# LOCKHART SOLAR PV II PROJECT

## FINAL ENVIRONMENTAL IMPACT REPORT

SCH# 2021070070

APRIL 2022

## FINAL EIR REVISED FIGURE 3-3: Aerial Map

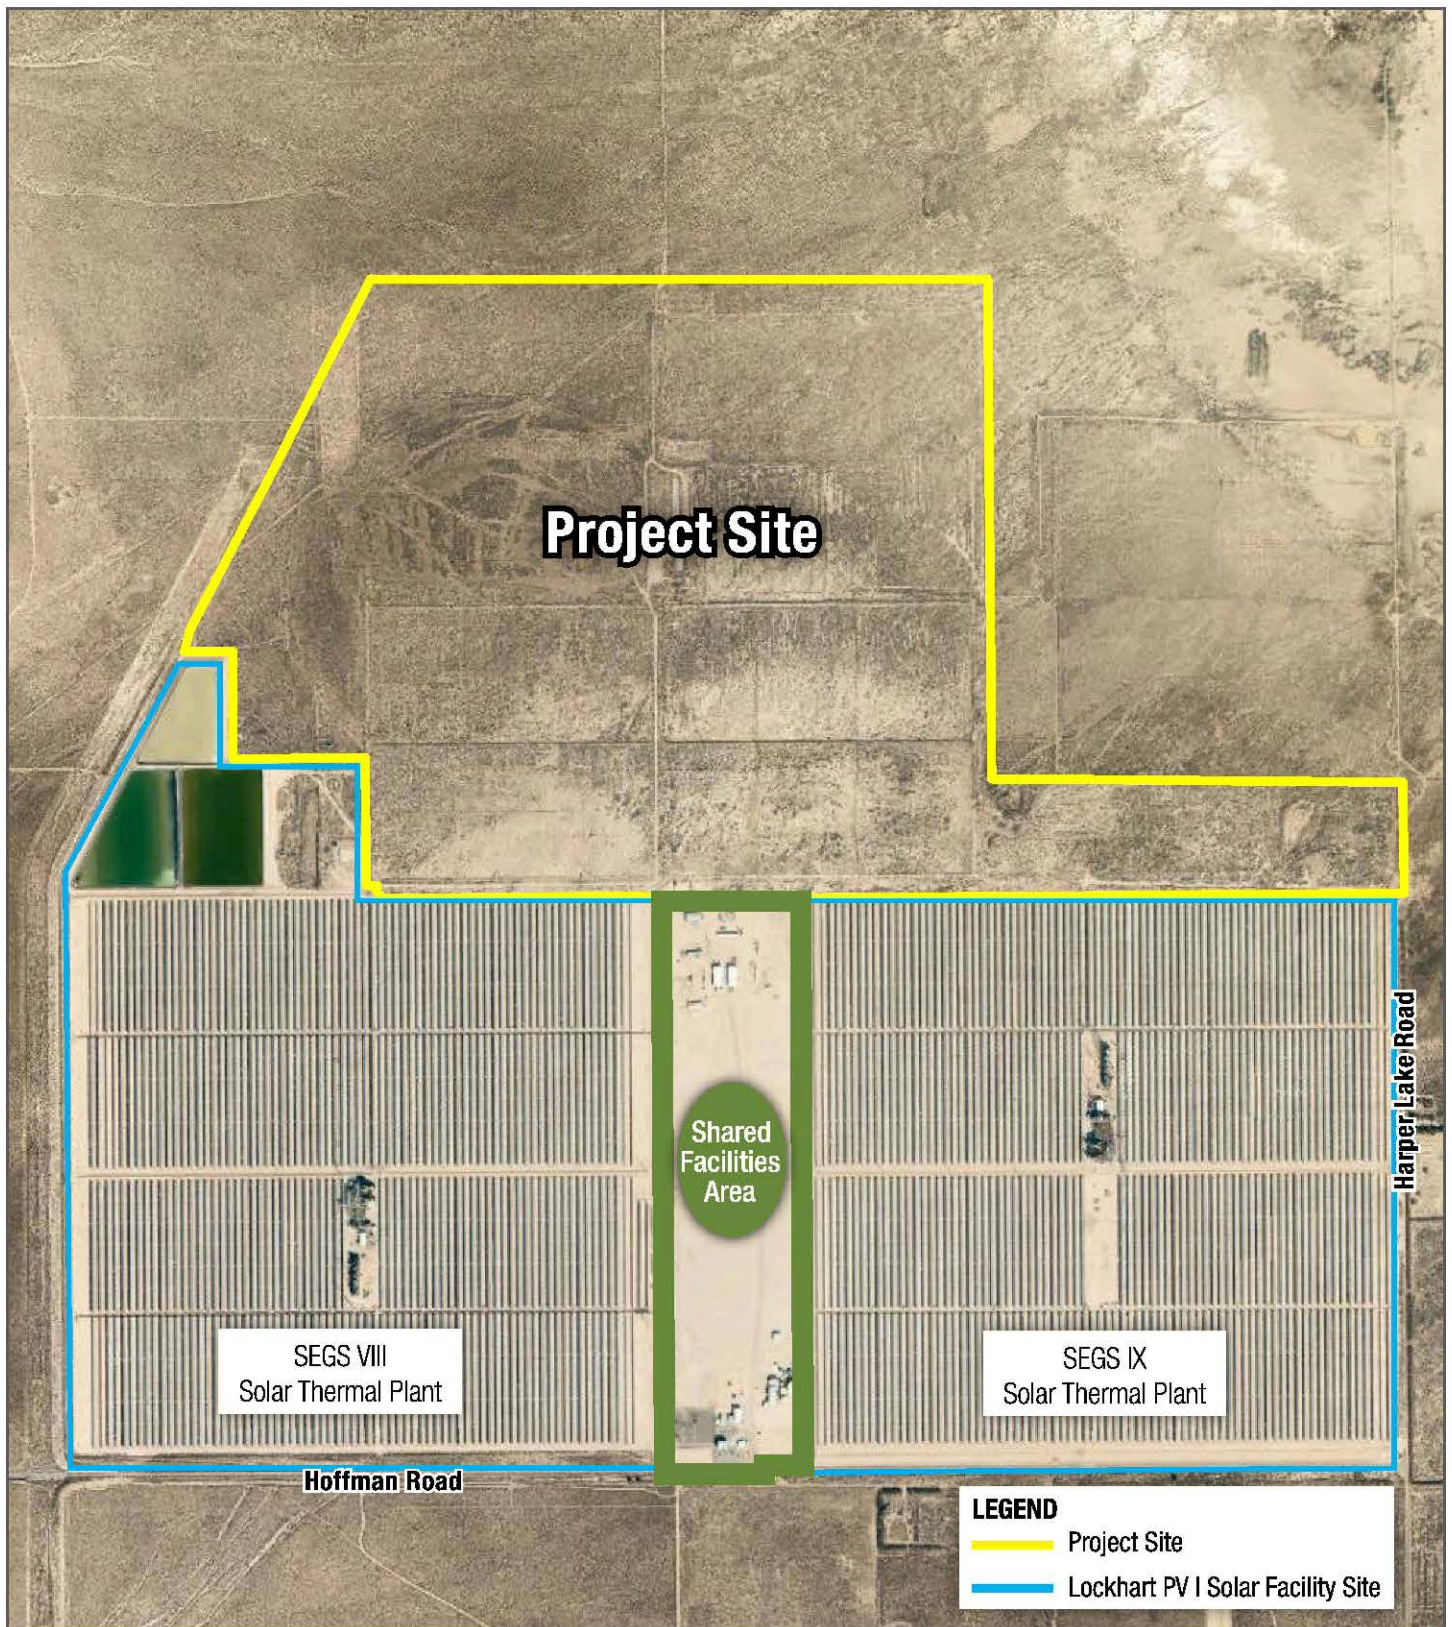
3. Page 3-5, Figure 3-3 is revised below.
4. Page 3-7, Figure 3-4 is revised below.

## FINAL EIR REVISED FIGURE 4.1-1: Surrounding Land Uses

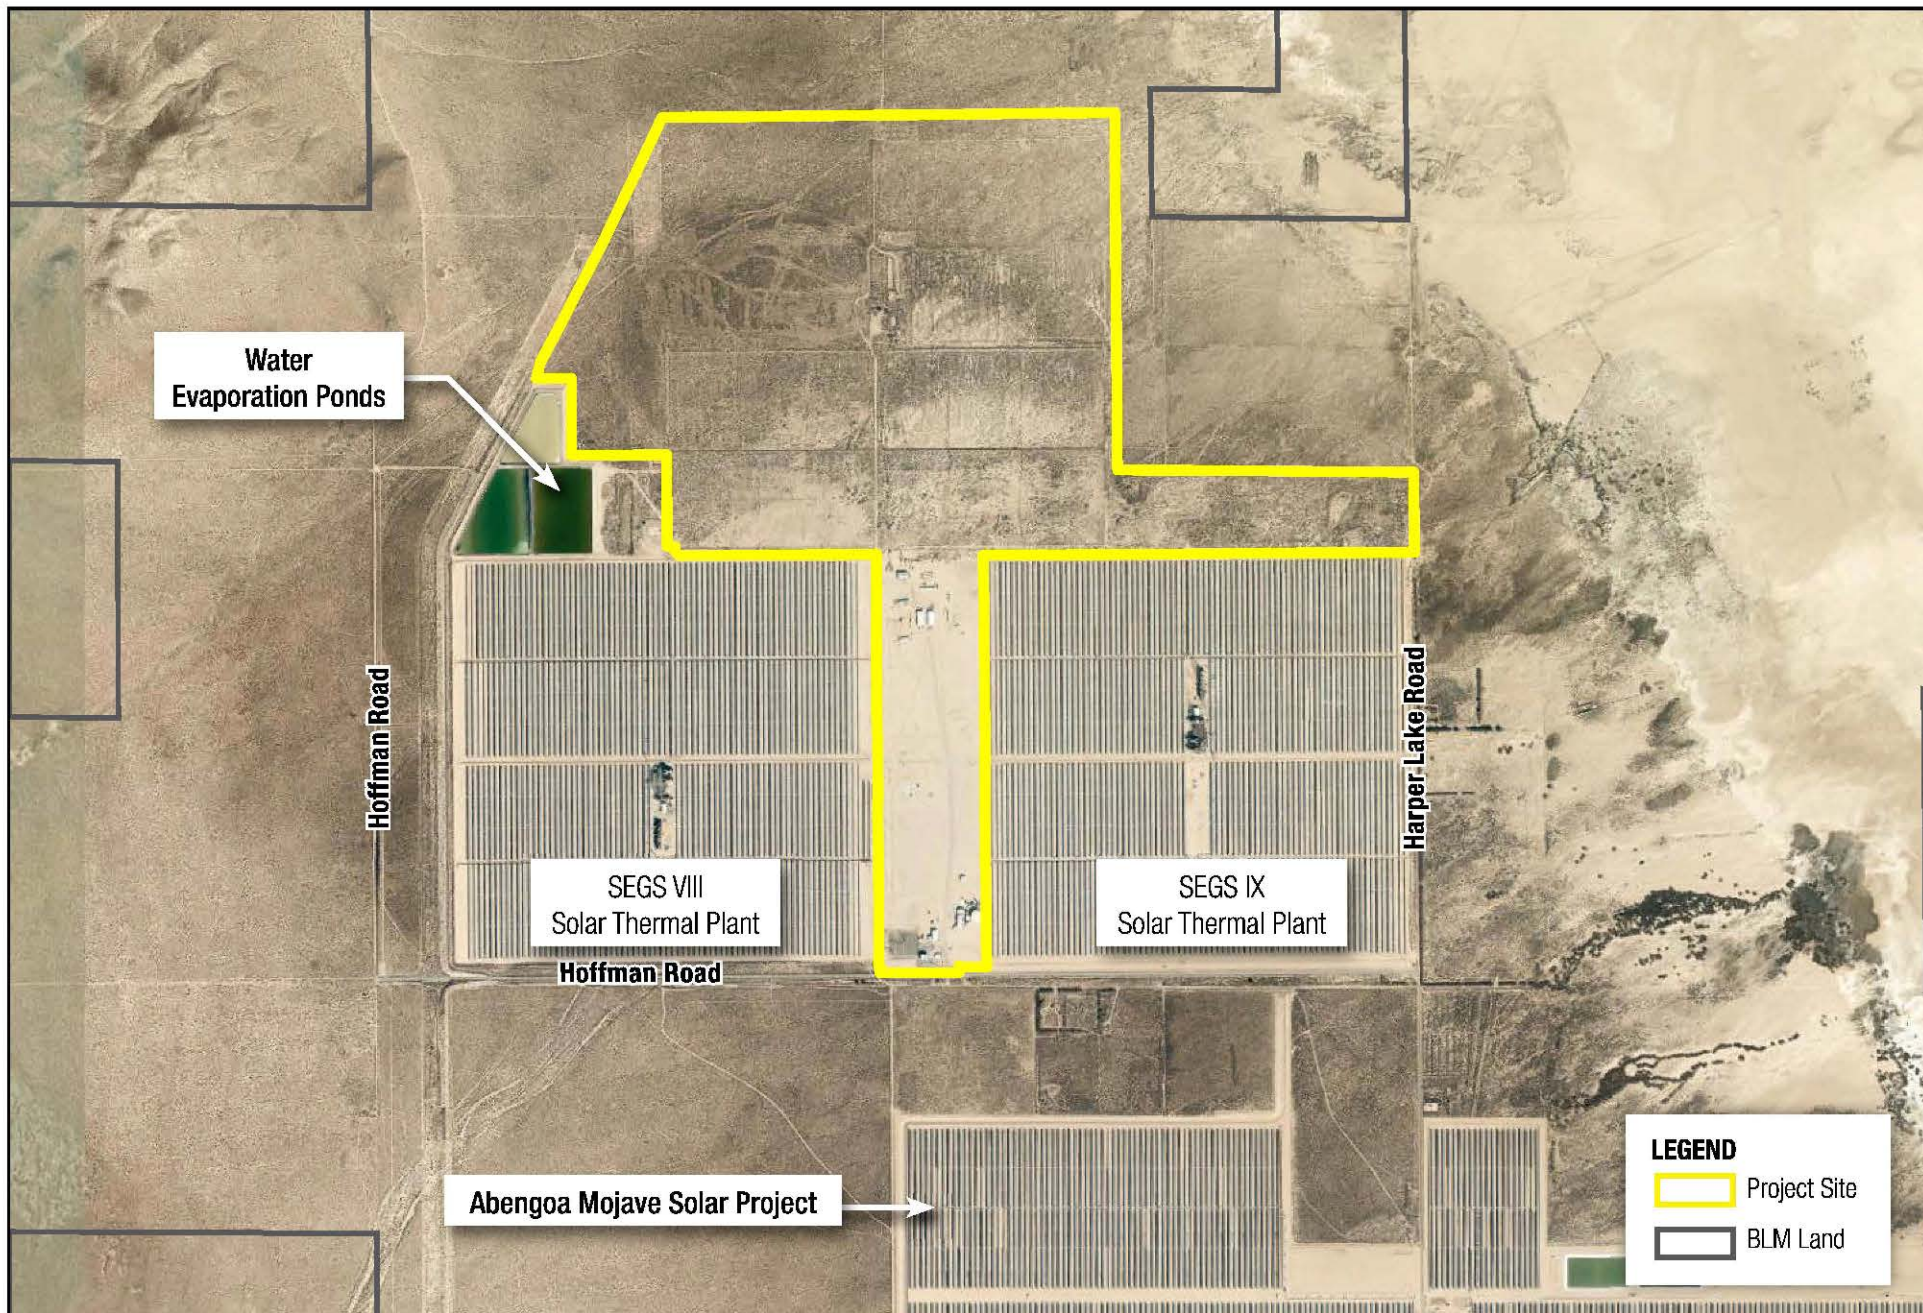
1. Page 4.1-3, Figure 4.1-1 is revised as follows:

**FINAL EIR REVISED FIGURE 4.3-2a: Biological Reconnaissance Survey and Jurisdictional Delineation Area**

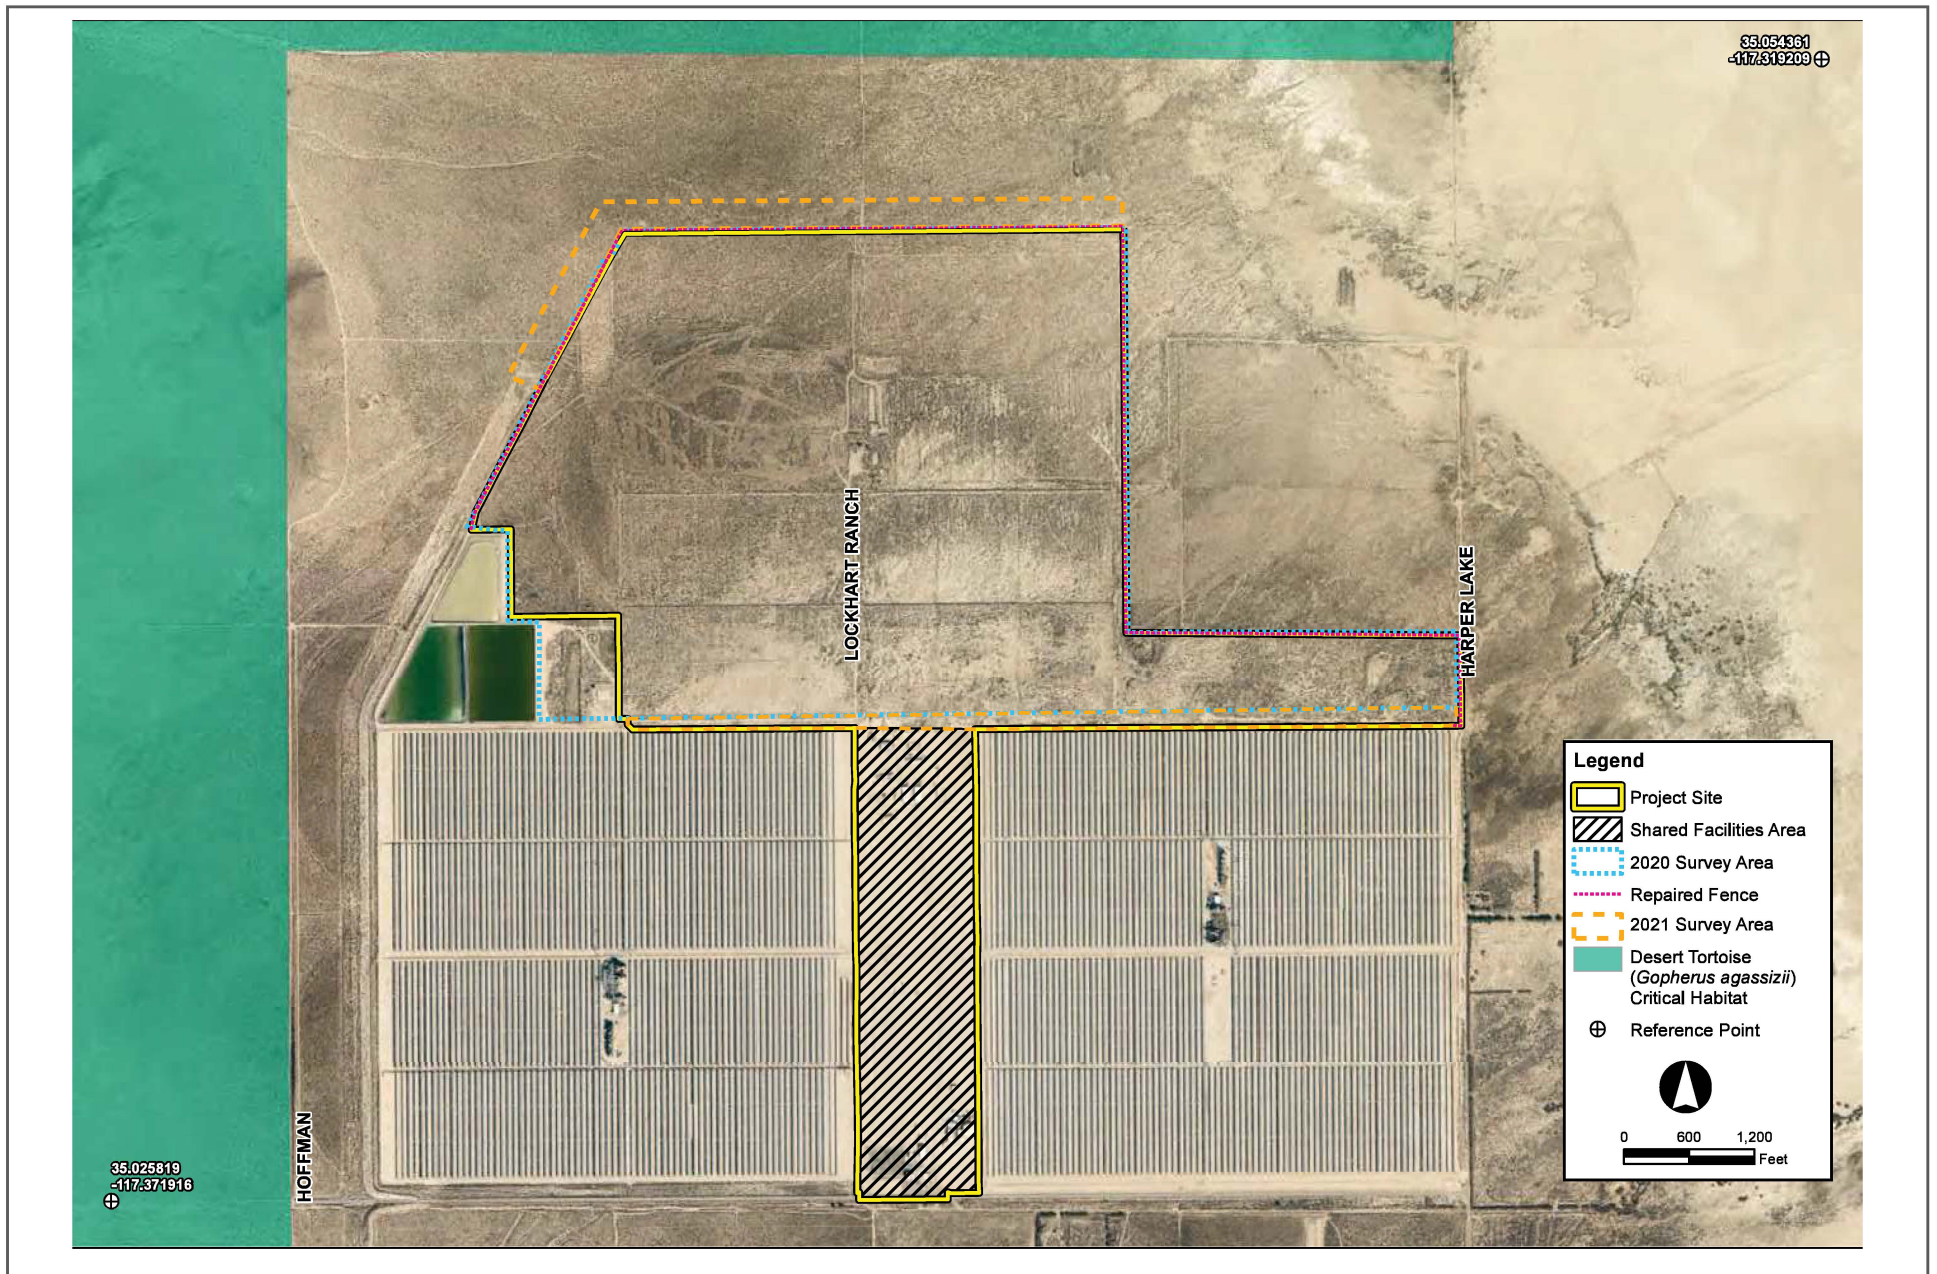
1. Page 4.3-4, Figure 4.3-2a is revised below.
2. Page 4.3-6, Figure 4.3-2c is revised below.
3. Page 4.3-8, Figure 4.3-3 is revised below.
4. Page 4.3-43, the third sentence of the second paragraph of Mitigation Measure BIO-1 is revised as follows:

**FINAL EIR REVISED FIGURE 6-1: Reduced Acreage Alternative**

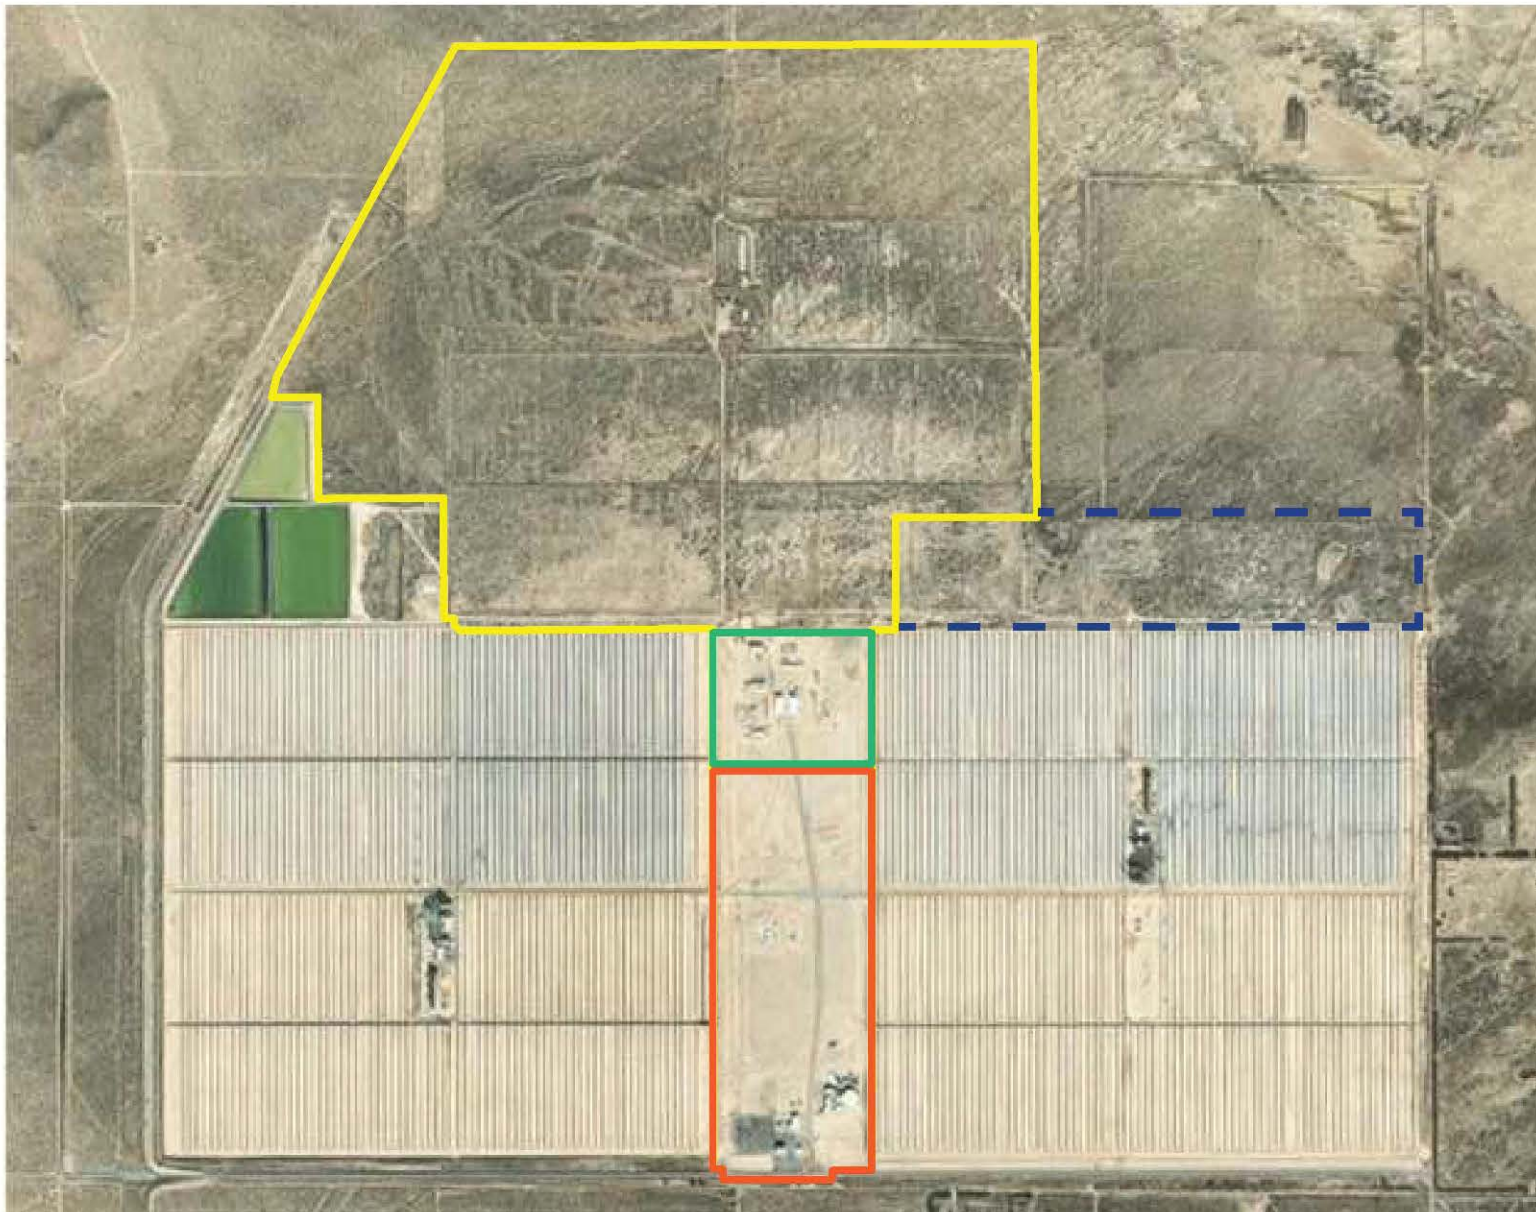
4. Page 6-7, Figure 6-1 is revised as follows:

Under the Reduced Acreage Alternative, the Project Site would be reduced to only include CUP Areas 1, 3, and 4. This alternative would reduce the Project's footprint from ~~755~~ 722 acres to 675 acres and would restrict construction of Project facilities to CUP Areas 1, 3, and 4 (see **Figure 6-1: Reduced Acreage Alternative**).
